ADDENDUM NO. 3 March 24, 2023 225107

## RE: ALBURGH VILLAGE WATER TANK REPLACEMENT

## I. Contract Documents (Drawings) Changes

ELEVATED WATER STORAGE TANK NOT TO SCALE

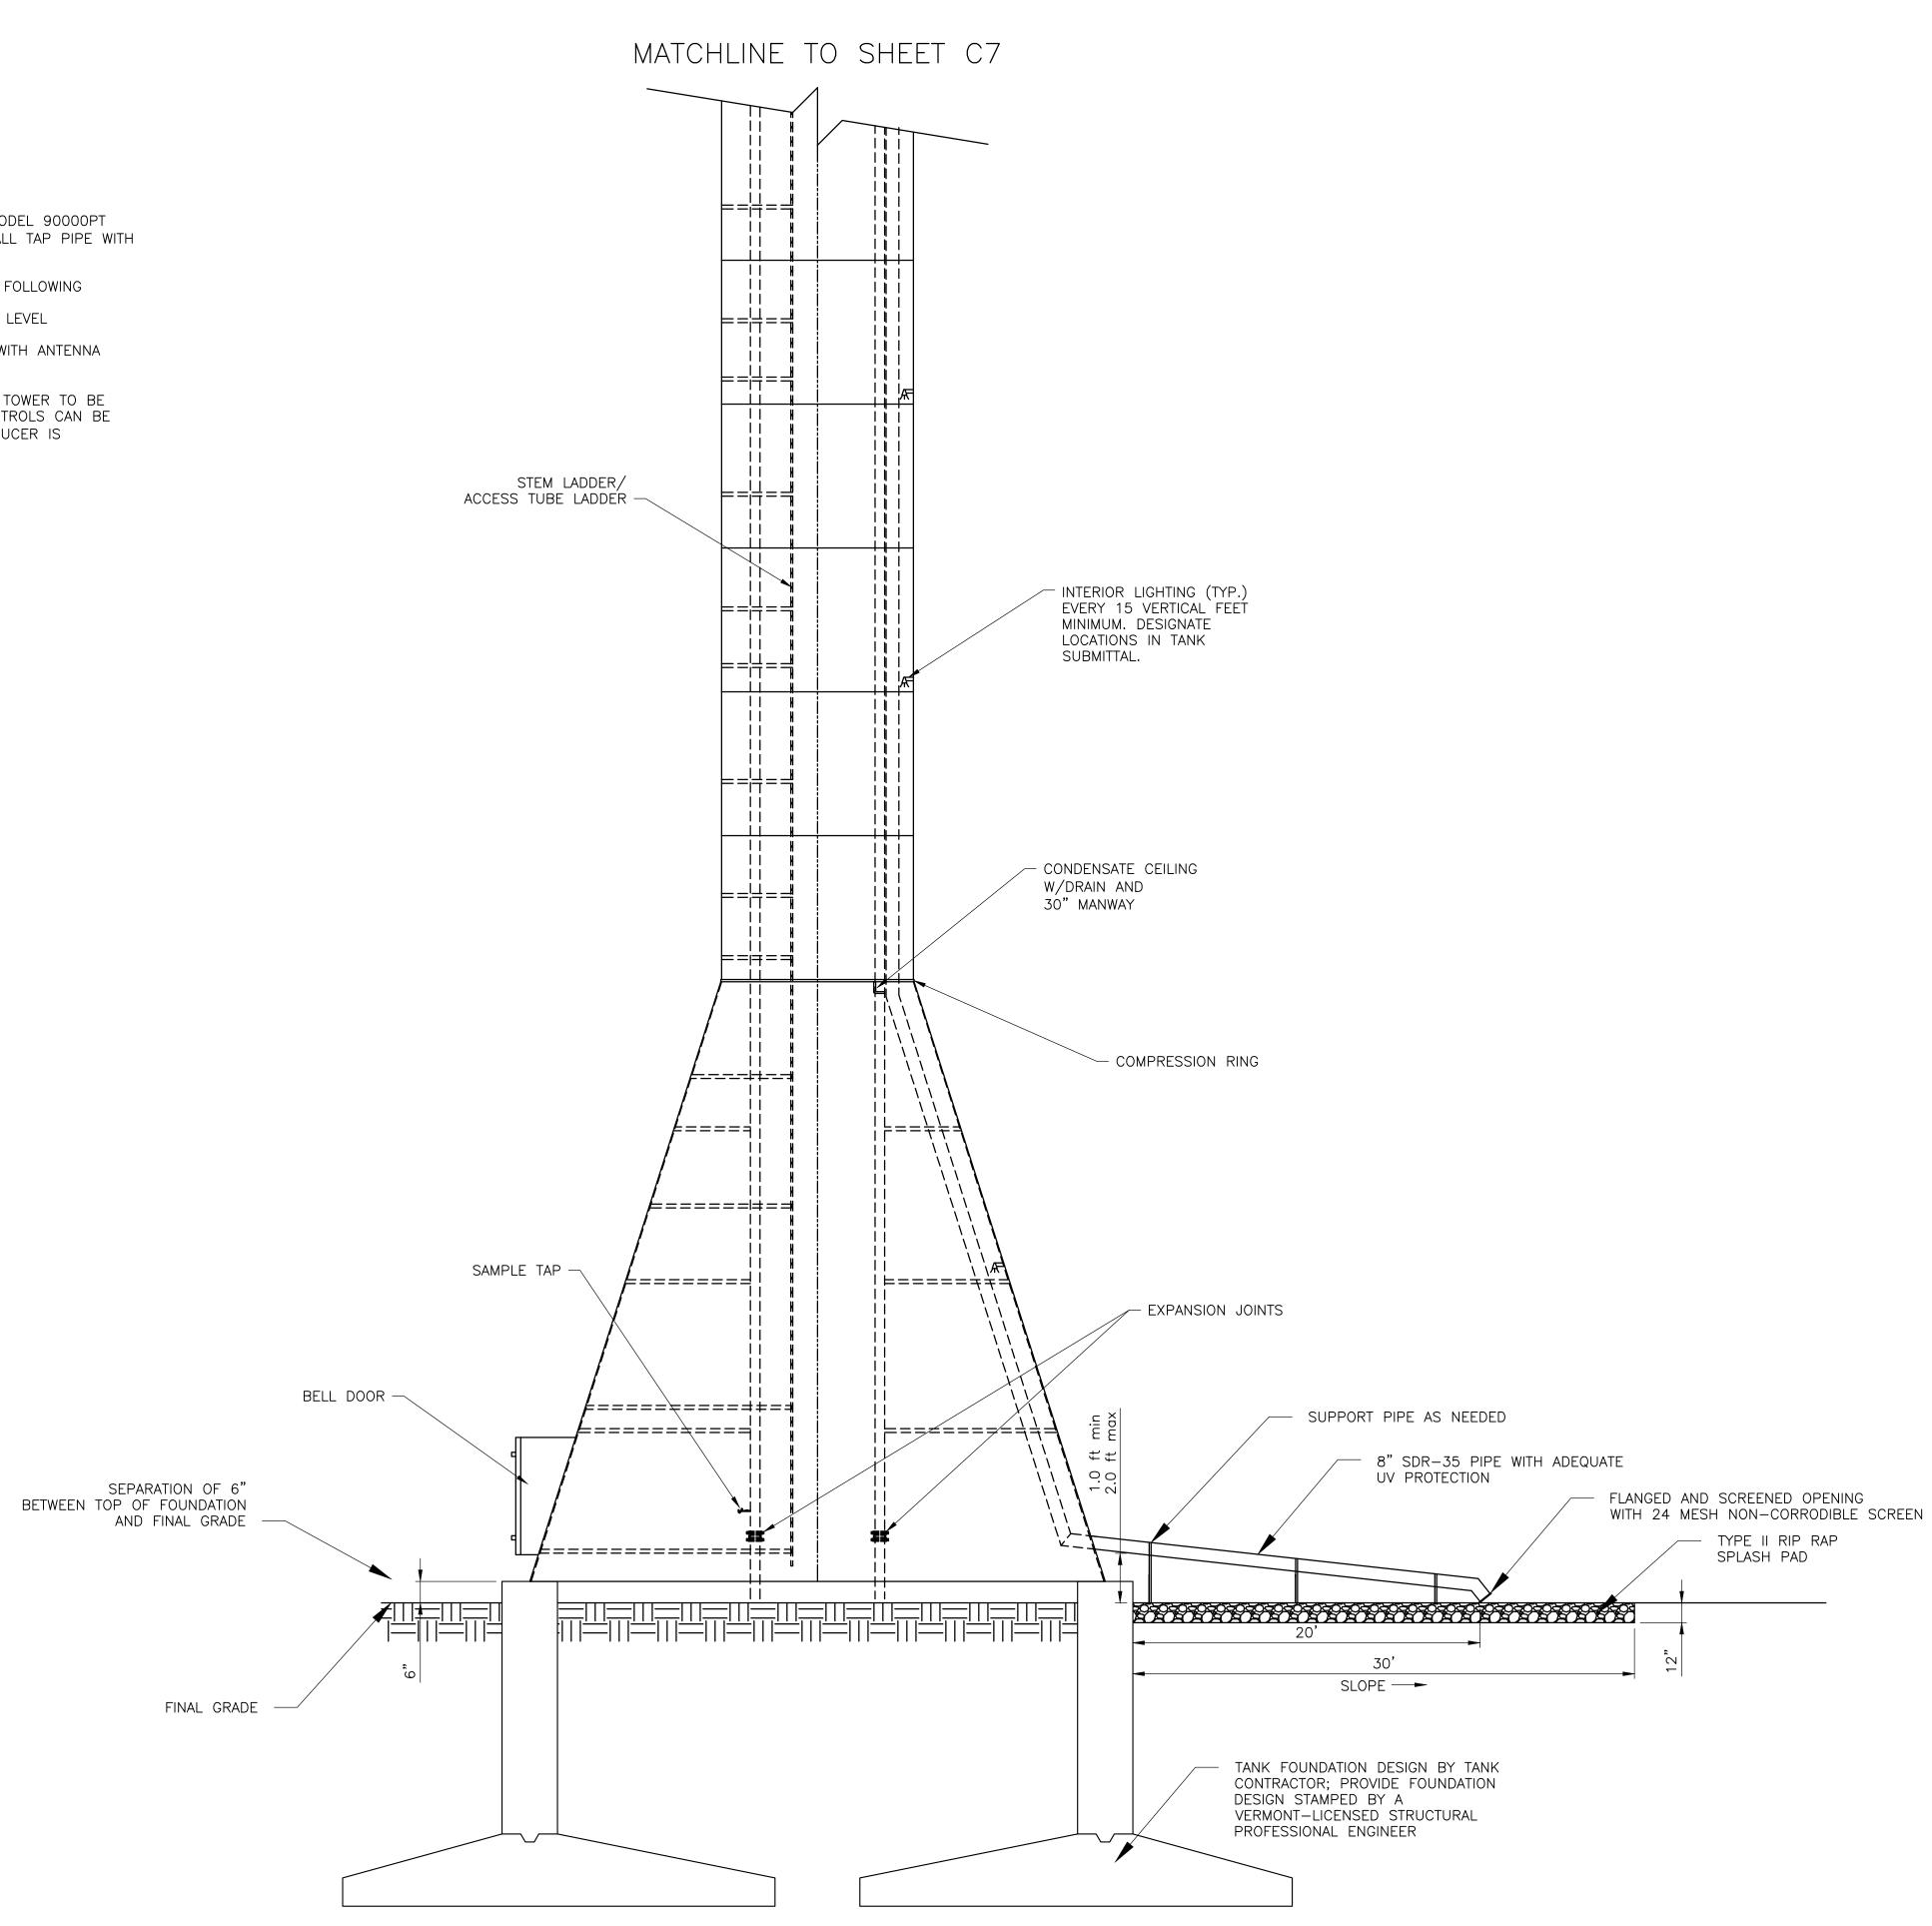
PROVIDE WATER TANK LEVEL TRANSDUCER (SIGMA CONTROLS, INC. MODEL 90000PT PRESSURE TRANSMITTER OR APPROVED EQUAL). PROVIDE AND INSTALL TAP PIPE WITH SHUTOFF VALVE SUITABLE FOR THE PRESSURE CONDITIONS.

THE CONTRACTOR'S WORK SEQUENCING SHALL ALLOW FOR THE NEW TOWER TO BE BUILT, THEN THE CONTROL PANEL TO BE SWAPPED OVER. THE CONTROLS CAN BE RUN IN CONTROL TYPE 2 (PID) MODE WHILE THE PRESSURE TRANSDUCER IS INSTALLED ON THE NEW TOWER.

SHEET 11 OF 13		SHEET 11 OF 13

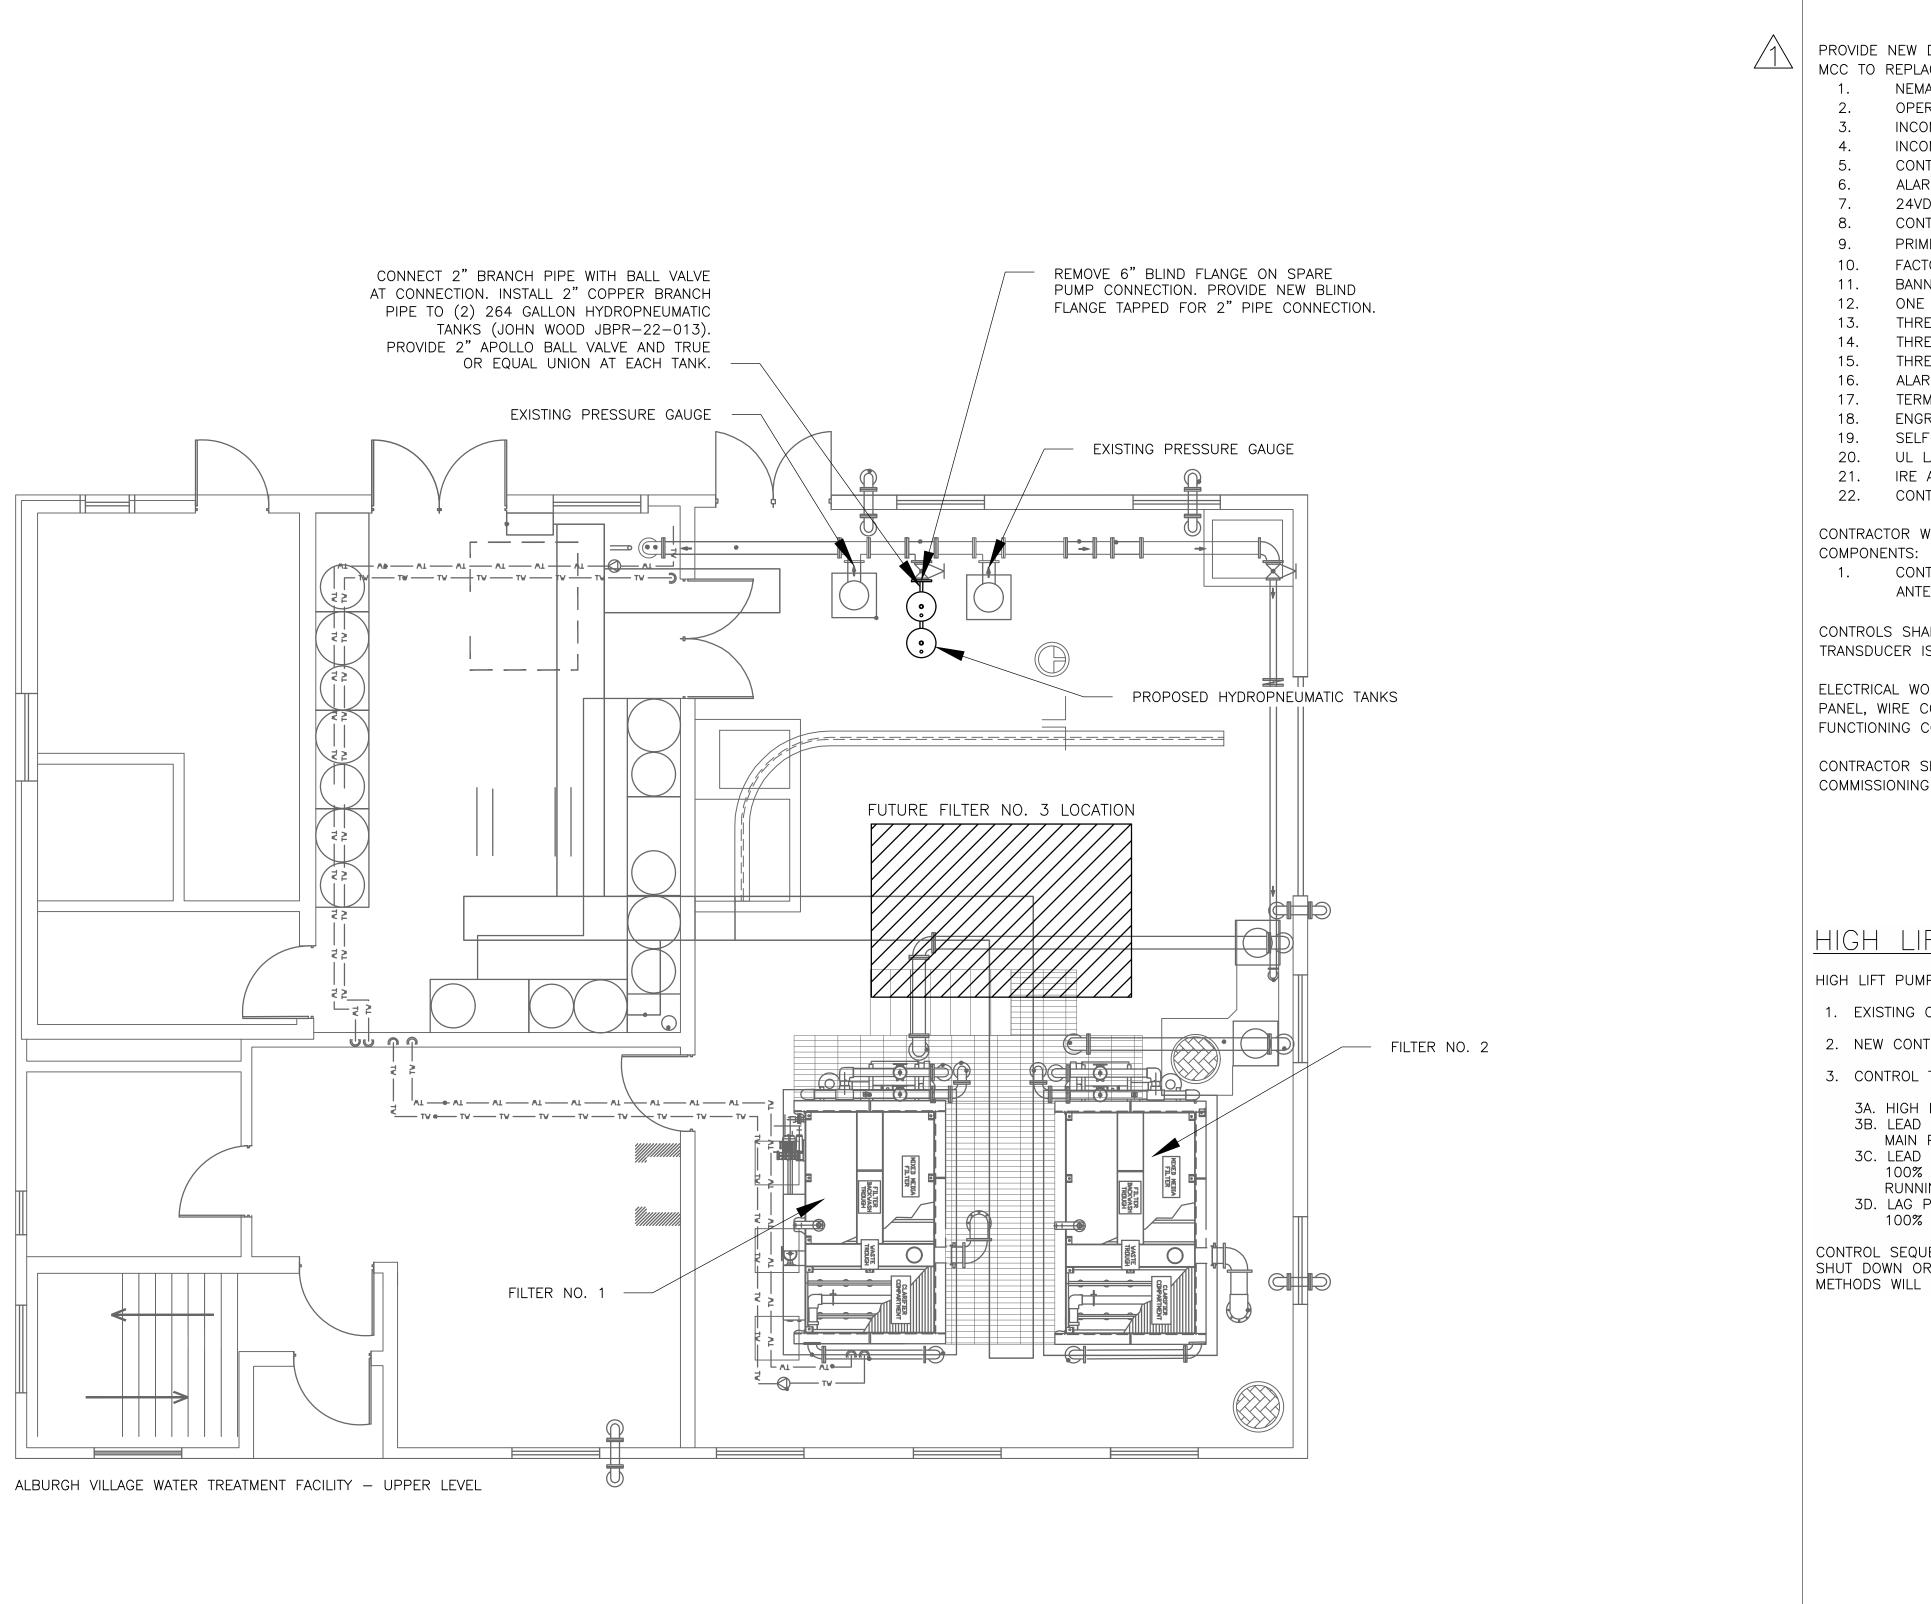
TROL SEQUENCE SHALL BE PROGRAMMED AND BECOME CONTROL TYPE 2 TYPE 2 SHALL BE PROGRAMMED AS FOLLOWS: LIFT PUMPS SHALL ALTERNATE LEAD LAG. PUMP SHALL MAINTAIN 90 PSI AT EXISTING WATER PRESSURE SENSOR IN PLANT. PUMP SHALL THROTILE FROM 85% SPEED AT 90 PSI TO SPEED AT 75 PSI. LAG PUMP SHALL TURN OFF AFTER ING TWO MINUTES AT 80%. SPEED AT 75 PSI. LAG PUMP SHALL TURN OFF AT 85 PSI. JENCE TYPE 2 SHALL BE FOR 85% SPEETON. WATER CONSERVATION BE REQUIRED DURING CONTROL TYPE 2 USAGE. ALBURGH VILLAGE WATER TANK REPLACEMENT SHEET TITLE PNEUMATIC TANK PLAN DRAWN BY DATE AJL JAN. 2022 CHECKED BY DAK PROJECTI? JBA 225107 PROLIBERG. DBK ARCHIVE? GPH					
ALBURGH VILLAGE WATER TANK REPLACEMENT SHEET TITLE PNEUMATIC TANK PLAN DRAWN BY AJL JAN. 2022 CHECKED BY JBA 225107 PROJ. ENG. DRAWN BY DATE AJL JAN. 2022 CHECKED BY DBA PROJECT # JBA 225107 PROJ. ENG. DRAWN BY DATE AJL JAN. 2022	TYPE 2 SHALL BE PROGRAMMED AS FOLLOWS: LIFT PUMPS SHALL ALTERNATE LEAD LAG. PUMP SHALL MAINTAIN 90 PSI AT EXISTING WATER PRESSURE SENSOR IN PLANT. PUMP SHALL THROTTLE FROM 84% SPEED AT 90 PSI TO SPEED AT 78 PSI. LEAD PUMP SHALL TURN OFF AFTER ING TWO MINUTES AT 80%. PUMP SHALL THROTTLE FROM 85% SPEED AT 85 PSI TO SPEED AT 75 PSI. LAG PUMP SHALL TURN OFF AT 85 PSI. JENCE TYPE 2 SHALL BE FOR SHORT-TERM USE IF THE TANK NEEDS TO BE R DRAINED FOR MAINTENANCE OR INSPECTION. WATER CONSERVATION	ALBURGH 1 NORTH MAIN ST. ALBURGH, VT

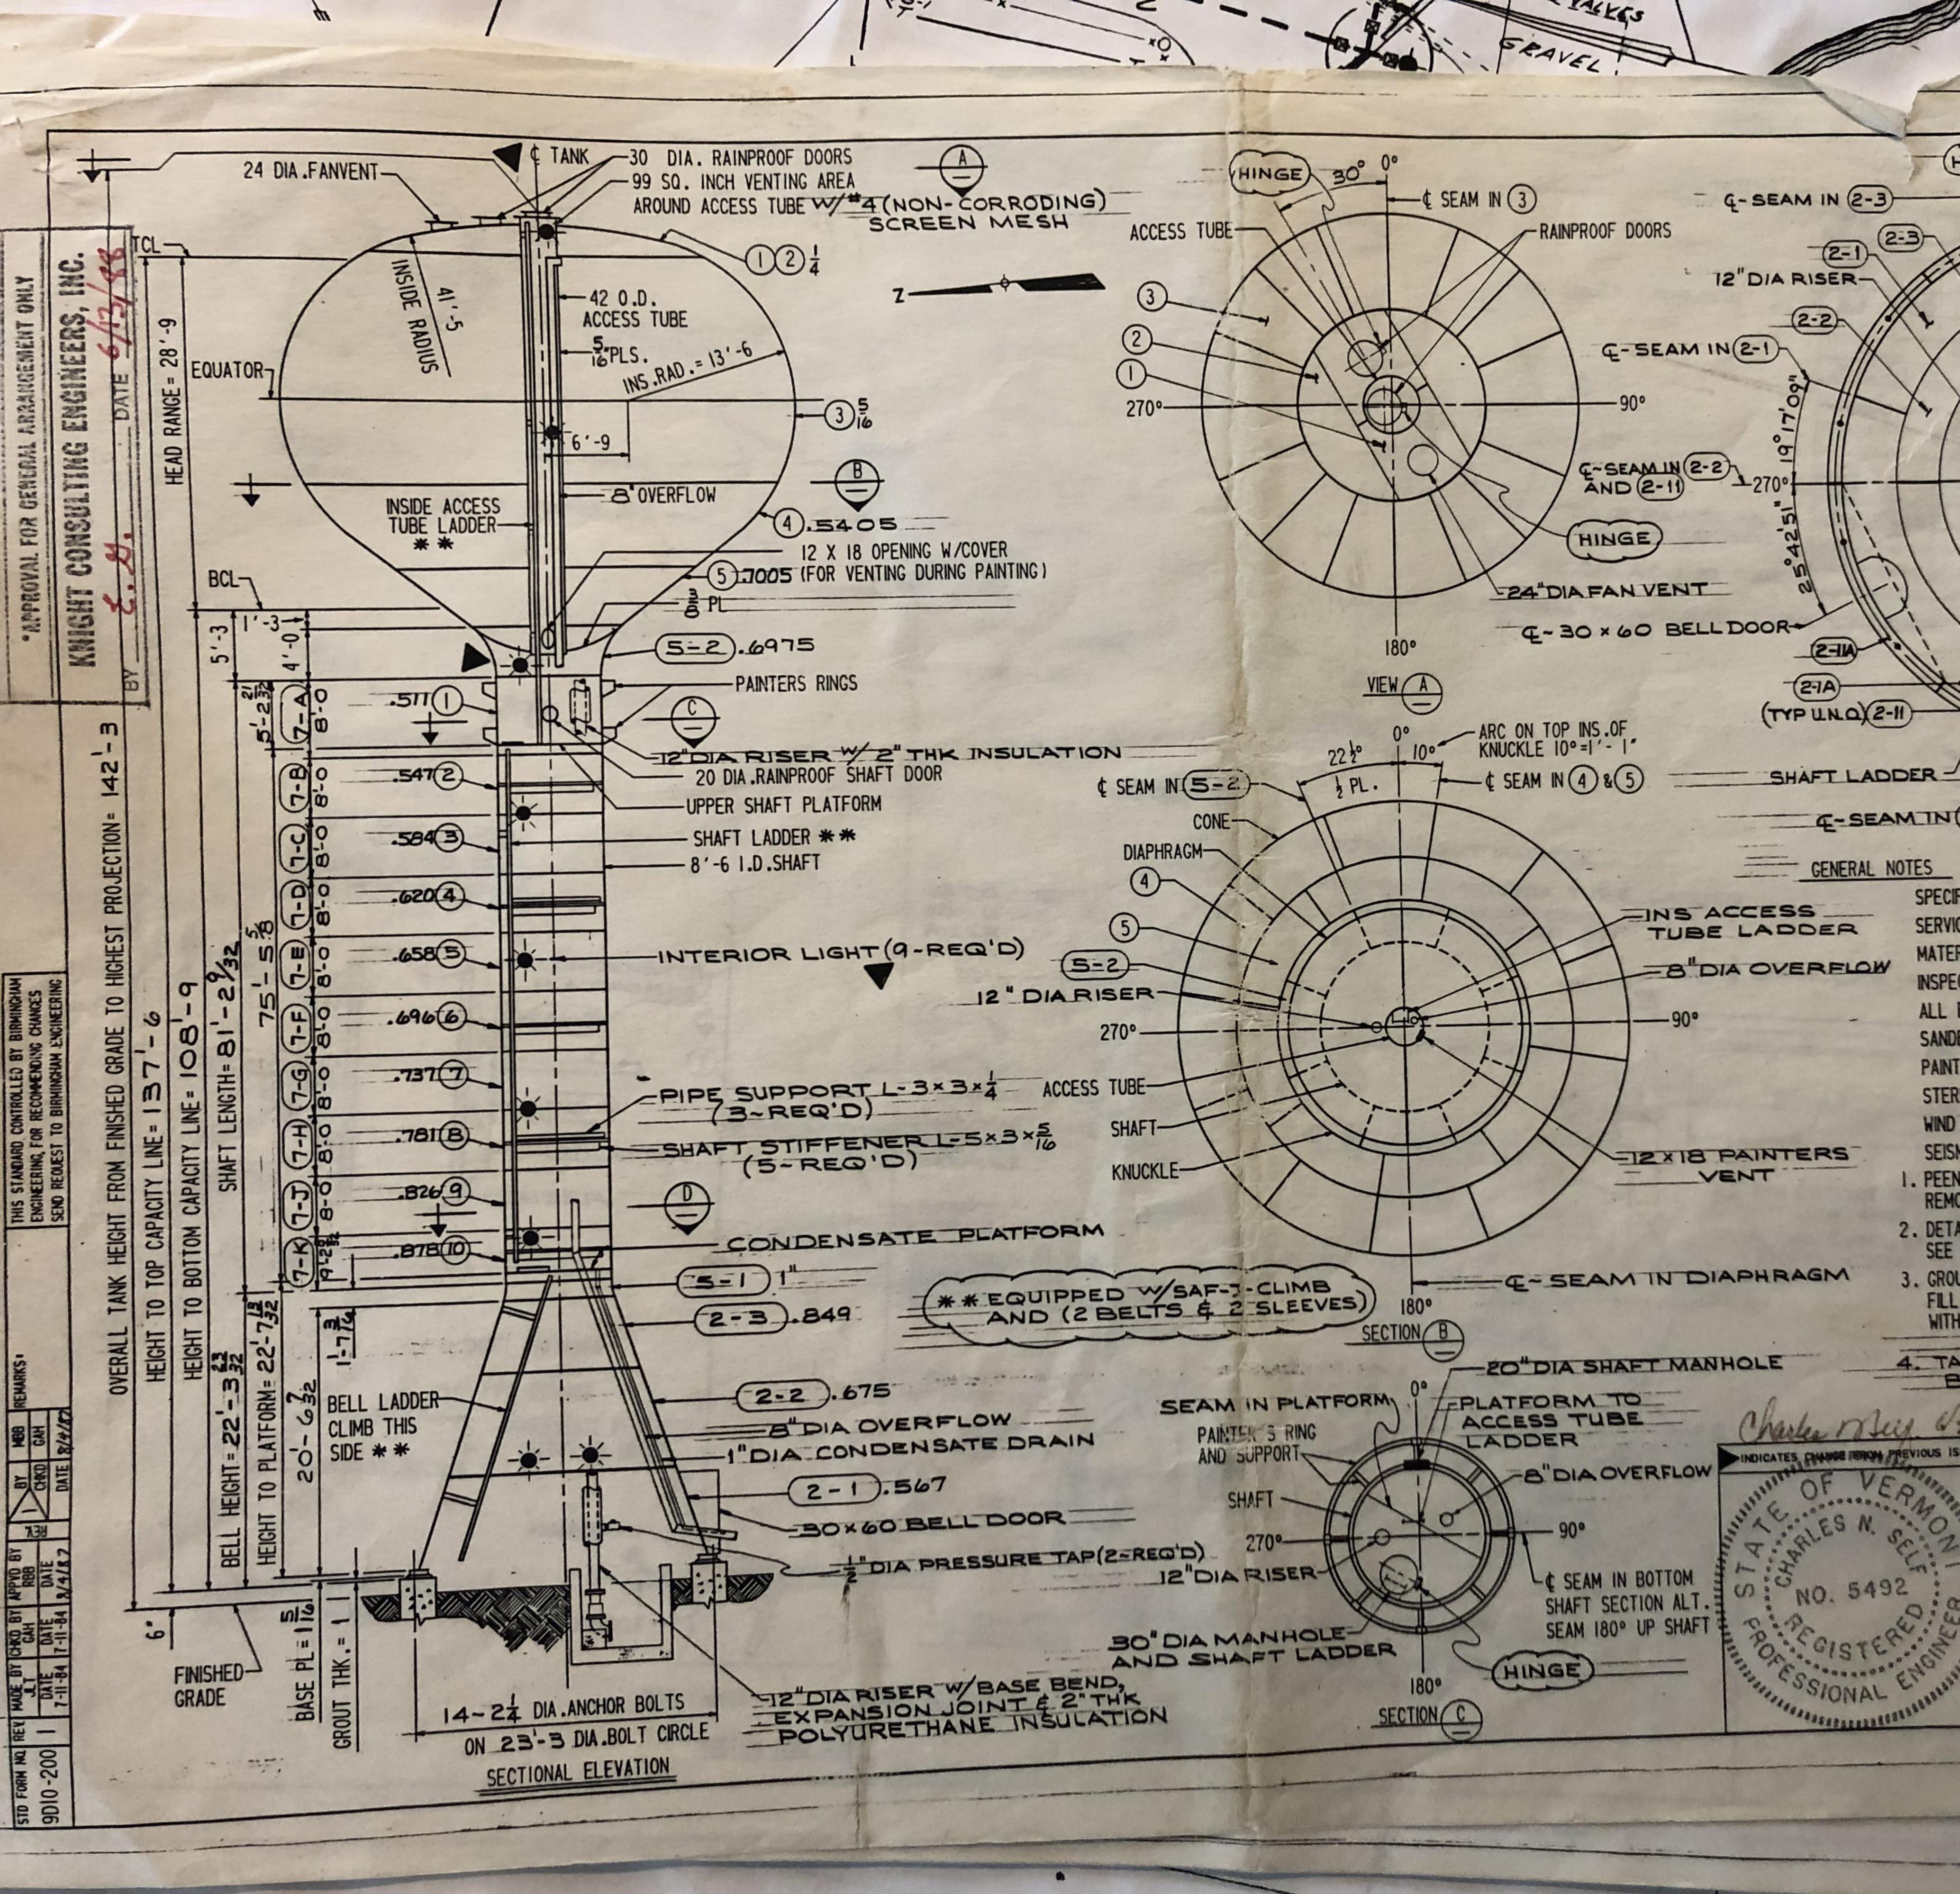
Question 1: Do you have any information on the thickness of the steel? Do you have as built drawings, actual height and diameter of the bulb as well as the diameter and thickness of the stem for the existing tank?

Answer 1: Available drawings of the existing tank are attached.
